**ADDENDUM NO. 2****Date of Issue: 1 February 2022**

Project: Renovations to Building 1000 Surgical Technology Lab  
Client: Horry-Georgetown Technical College  
State Project No.: H59-N085-PG  
DA Project No.: 21-106  
Prepared by: Doyle Architecture, LLC  
315 Main Street, Suite 2B  
Conway, South Carolina, 29526

SHEET:  
**E2.0**

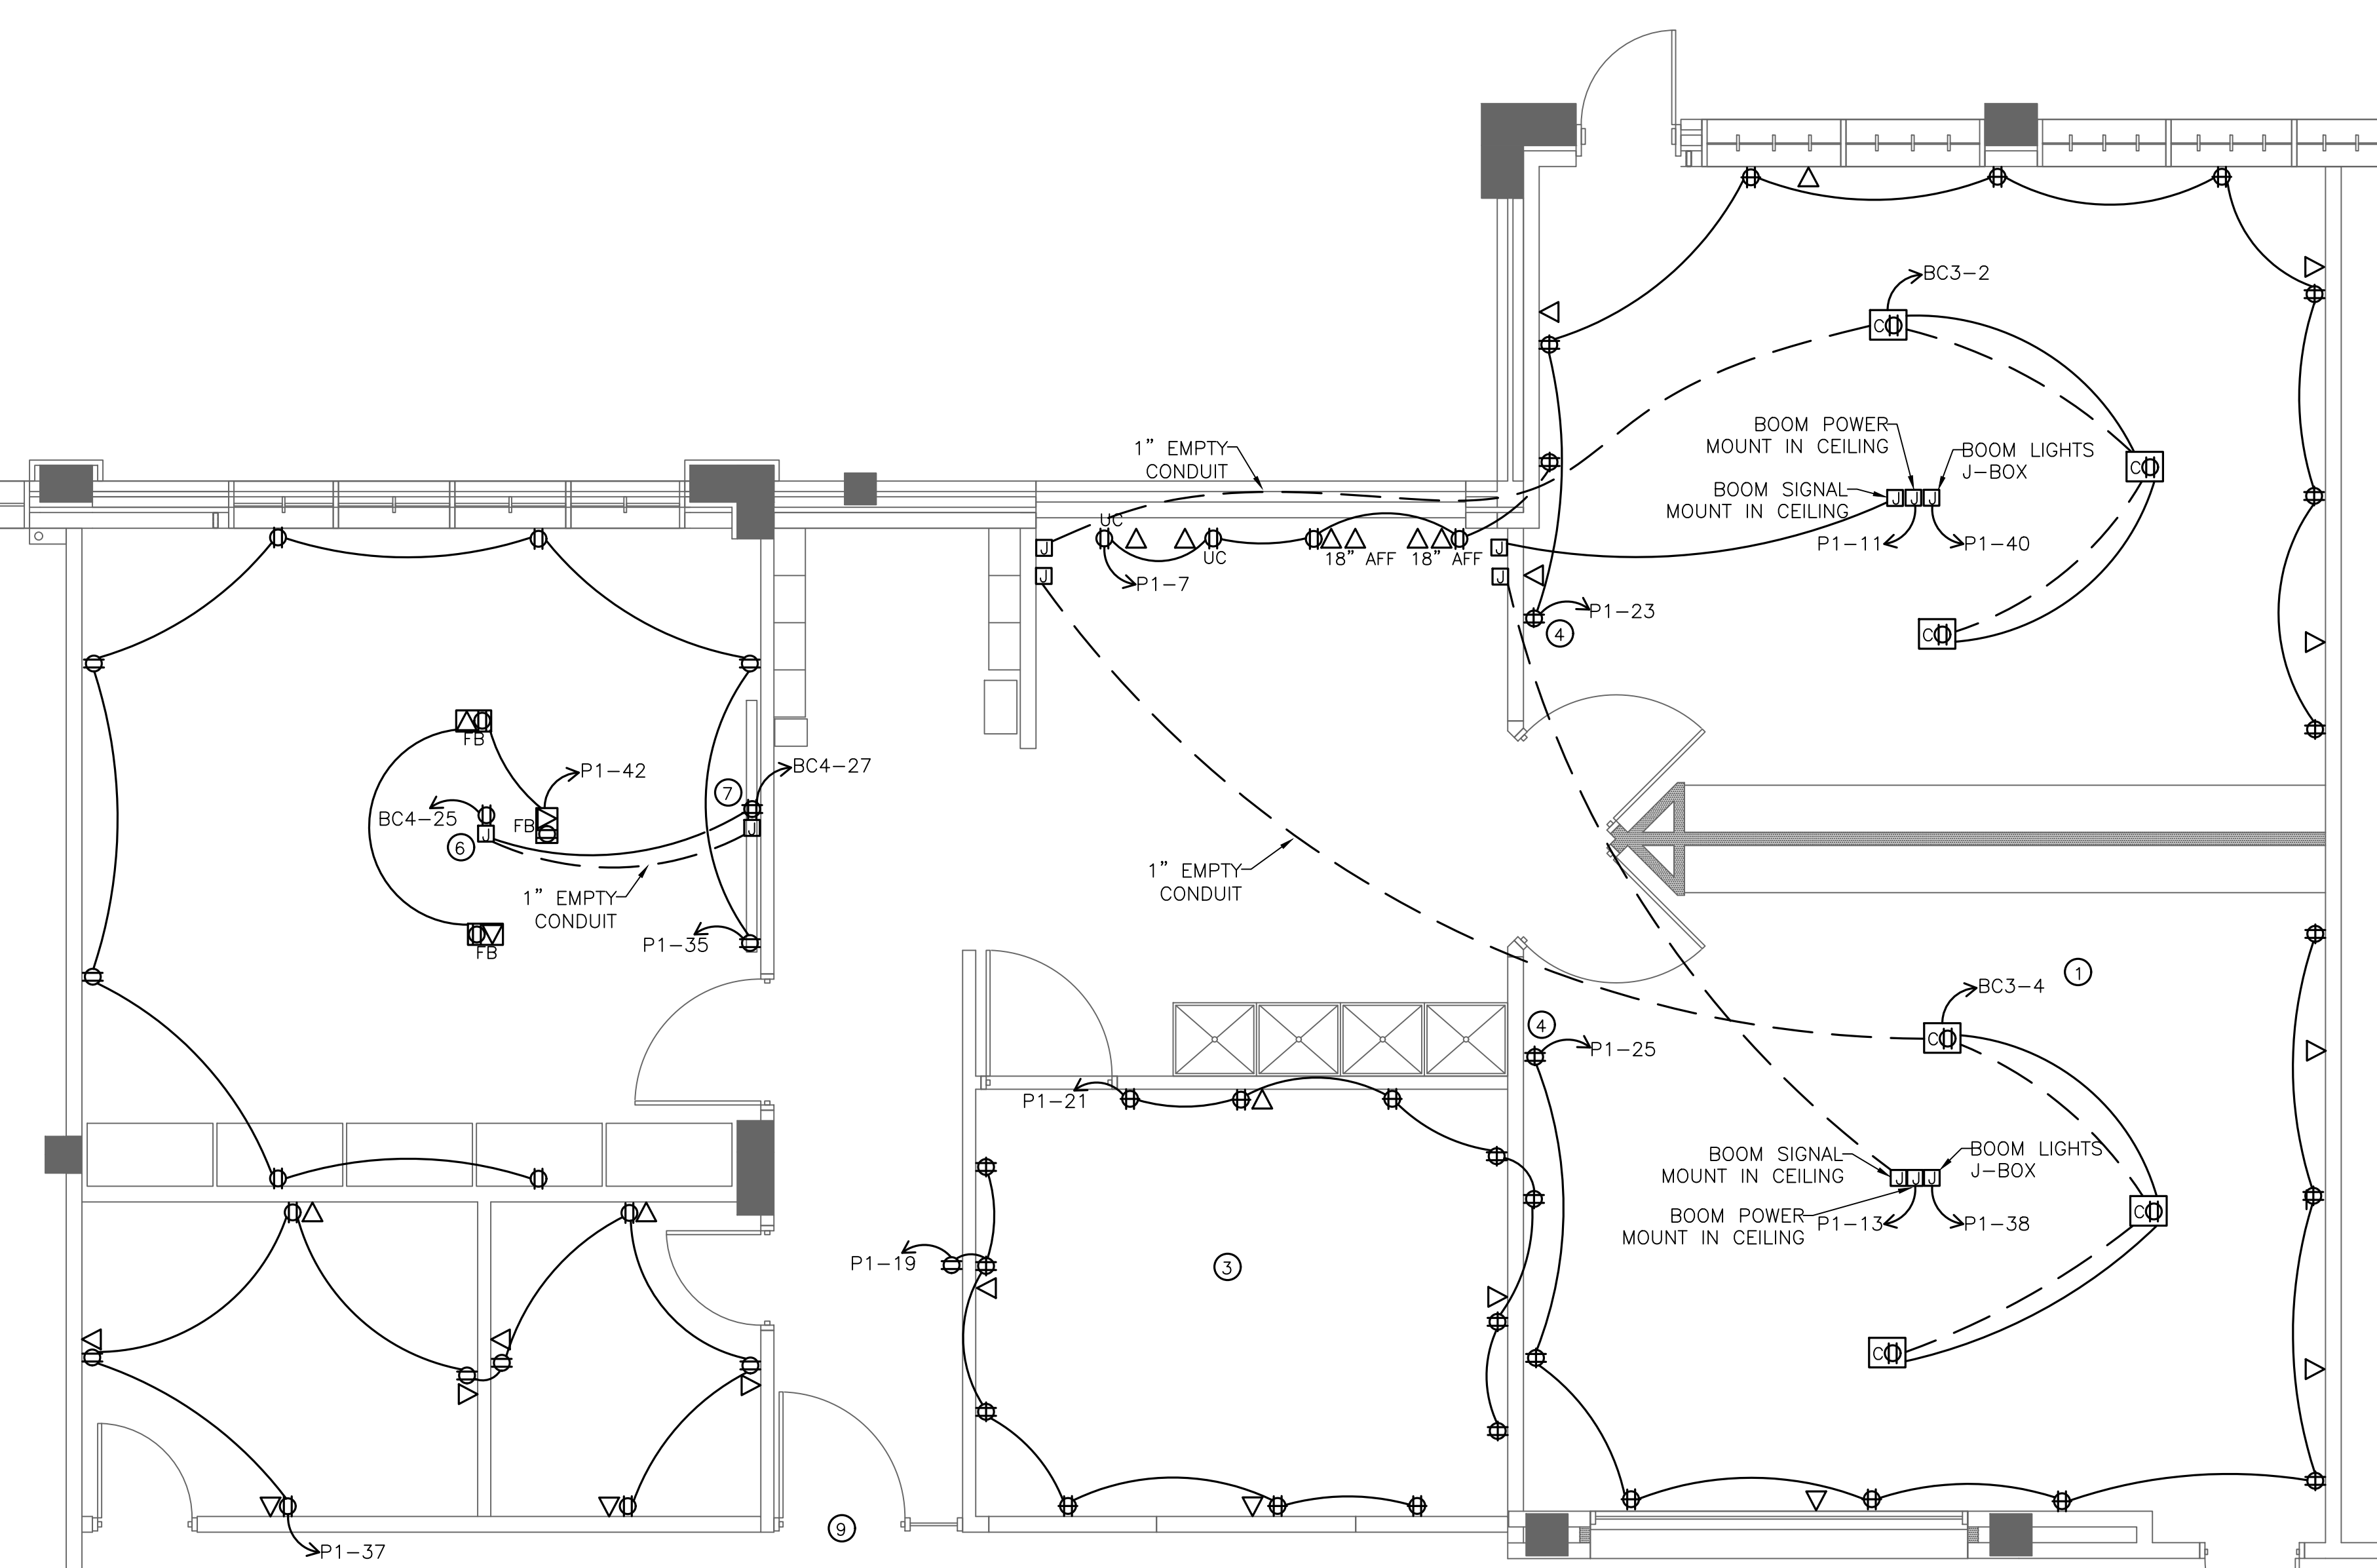
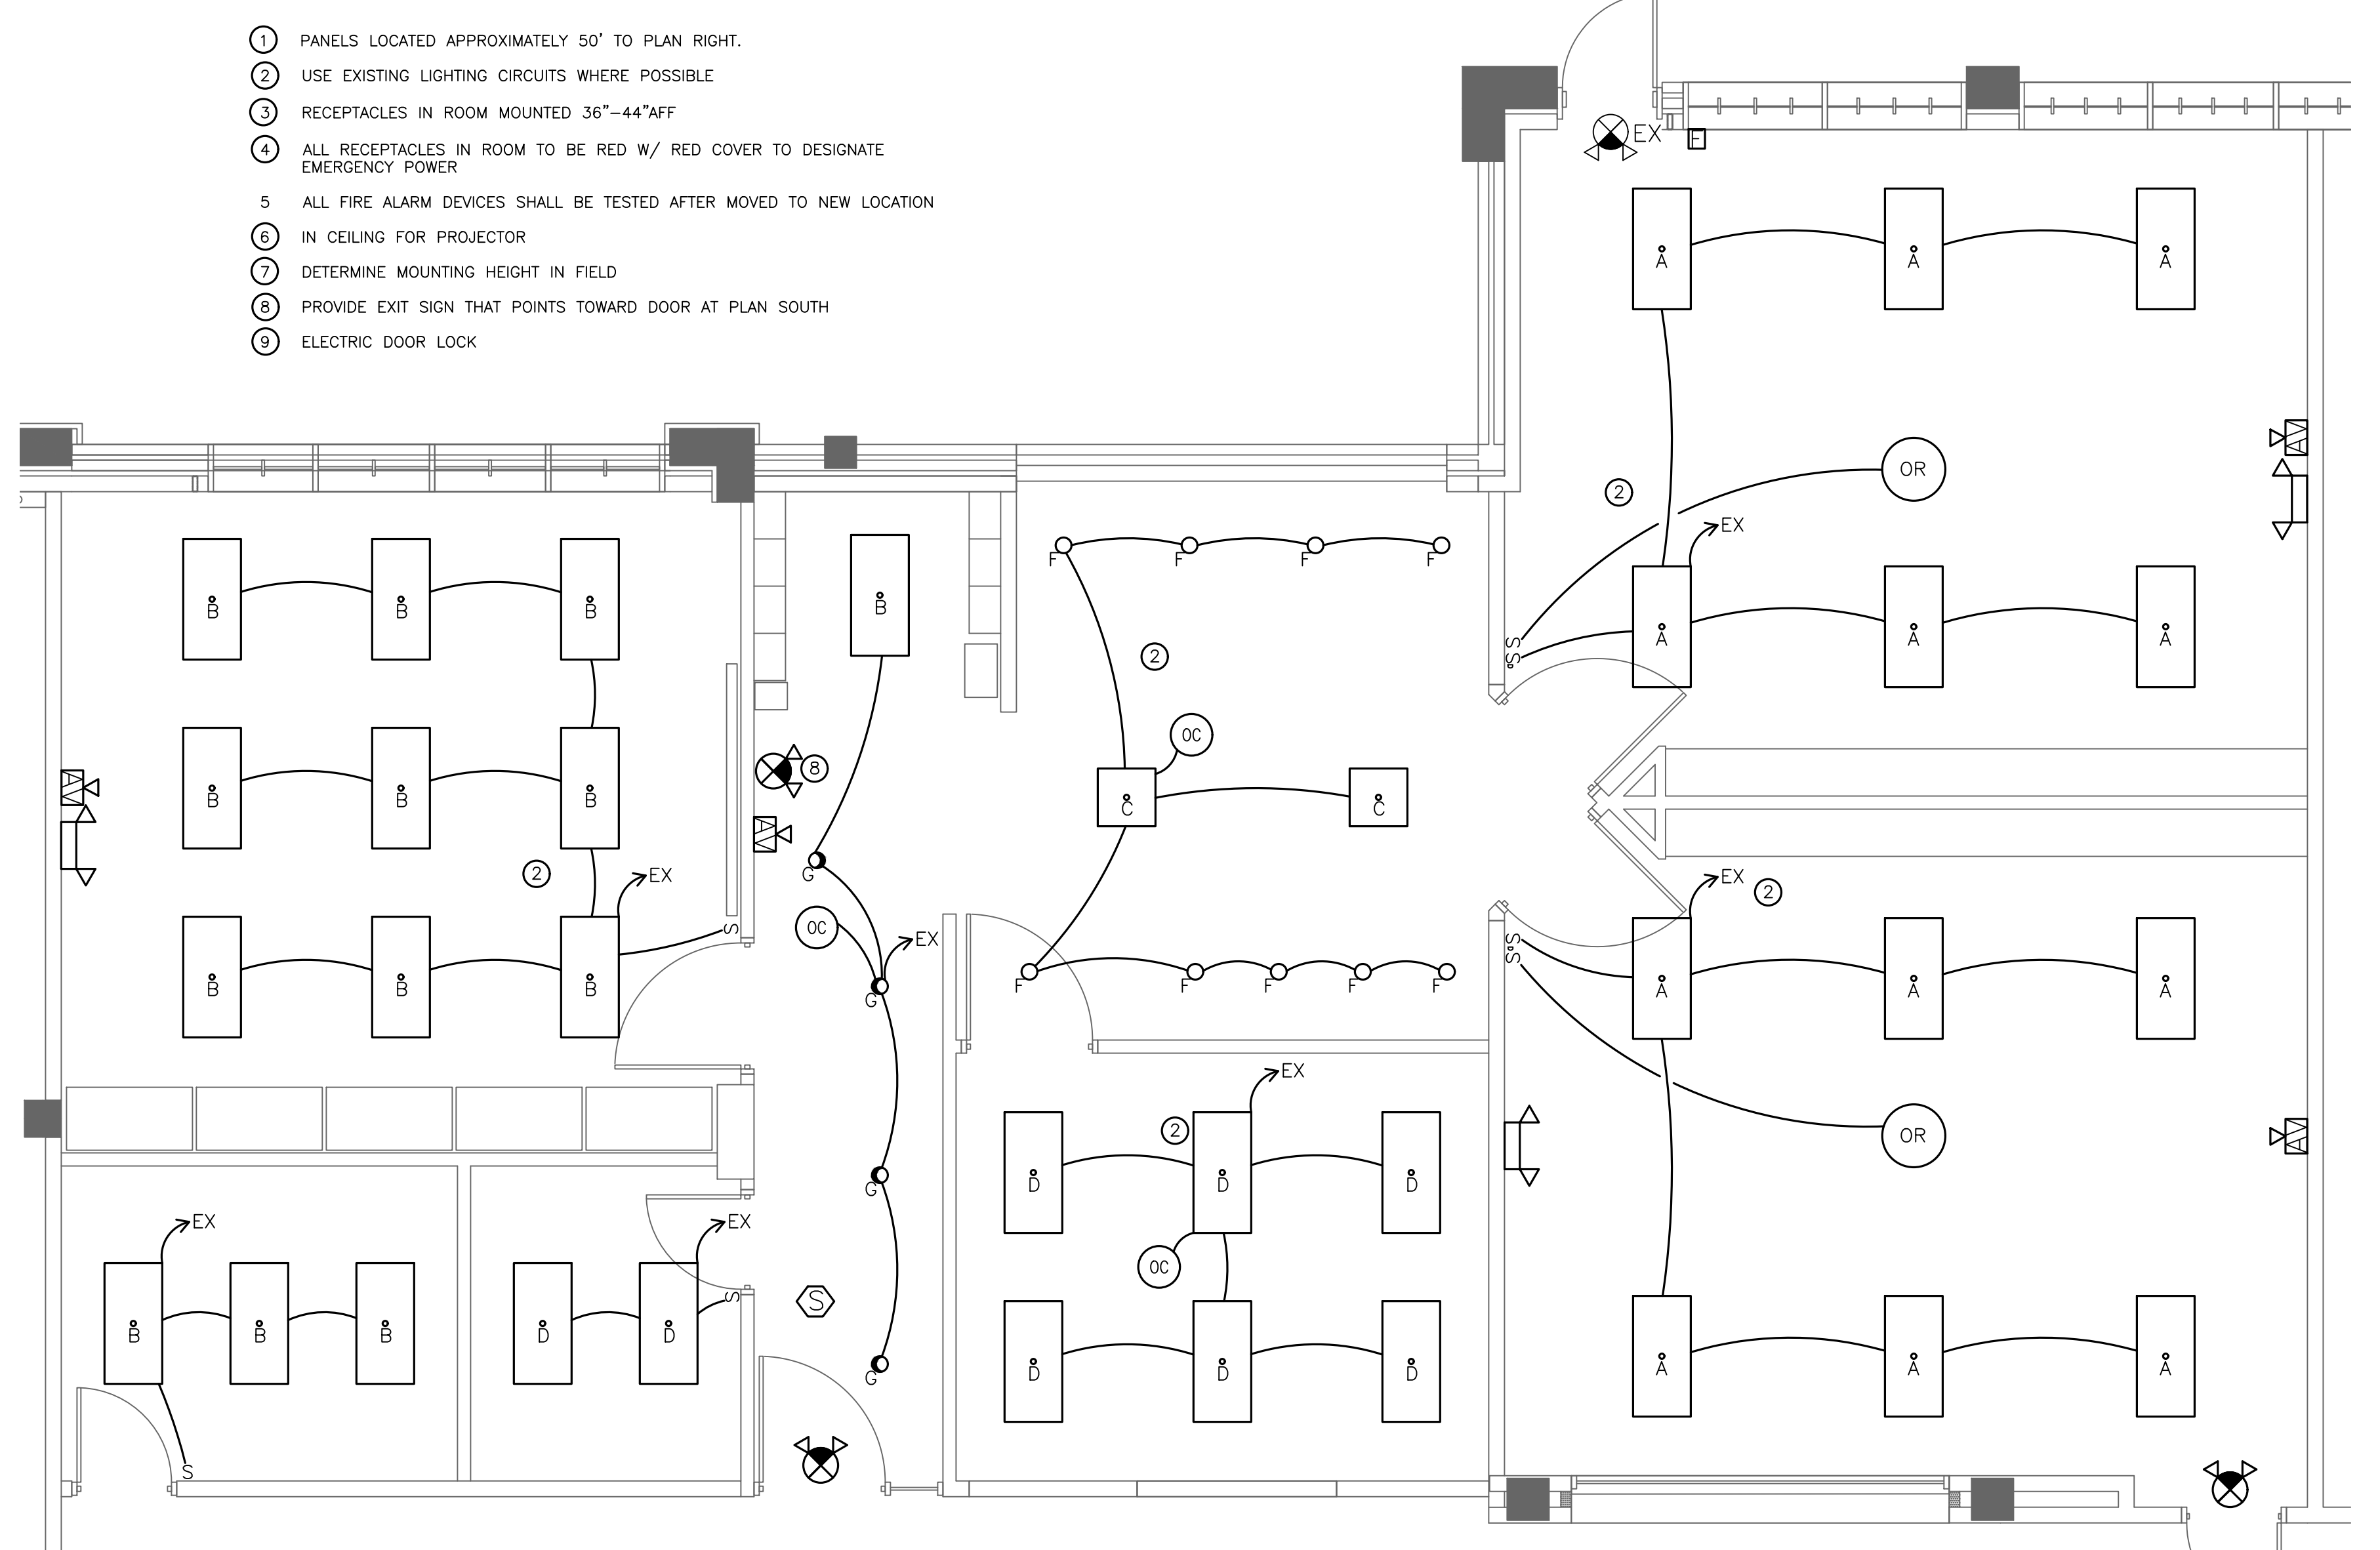
17. Sheet E2.0: General Electrical Notes
  - A. **ADD** Note 19 to read, “The electrical contractor to provide power to each camera location, and data conduit with backboxes for signal wire by others” as shown on the revised Sheet E2.0 issued with this addendum.

- THE ELECTRICAL CONTRACTOR TO PROVIDE POWER TO EACH CAMERA LOCATION, AND DATA CONDUIT WITH BACKBOXES FOR SIGNAL WIRE BY OTHERS.
